Subject: BAR Actions - 150 Chancellor Street- April 2015

BAR 15-04-02
150 Chancellor Street
Tax Parcel 090109000
Delta Zeta National Housing Corp., Owner/John J. Grottschall for Zeta Corp., Applicant
Replace windows; add new HVAC system

CITY OF CHARLOTTESVILLE BOARD OF ARCHITECTURAL REVIEW STAFF REPORT April 21, 2015

Compruter Mock-up of Exterior unit of lines placement W Fla as della 13 THE A If the care to The state of the s * I WY Law Law. ALC: TOTAL 网络 化 医亚 · 学人《型 基 Hitch 福田於祖思亞国第 XIIII A SECTION OF SECTION O 文 两种 医神经 8 Em (1) Em (2) The state of the s THE STATE OF Not the last 四個日本 抽片 TOTAL

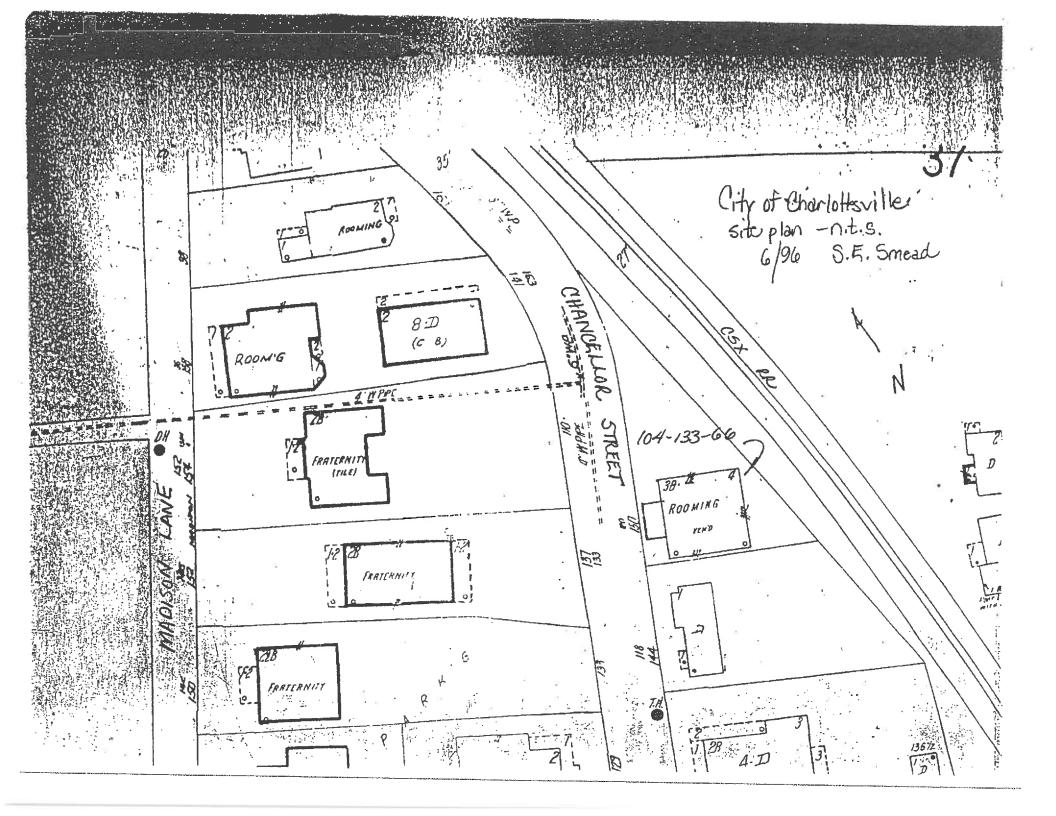
They also need an accurate depiction of where all the exterior mechanical units will be located, and where the exterior conduits will be located on the building, and what they will look like.

Regarding the HVAC upgrades, all the exterior mechanical units should be located in the rear, or if located on the sides, then they should be screened. The location and number of exterior conduits should be confirmed. Perhaps they can be painted brown.
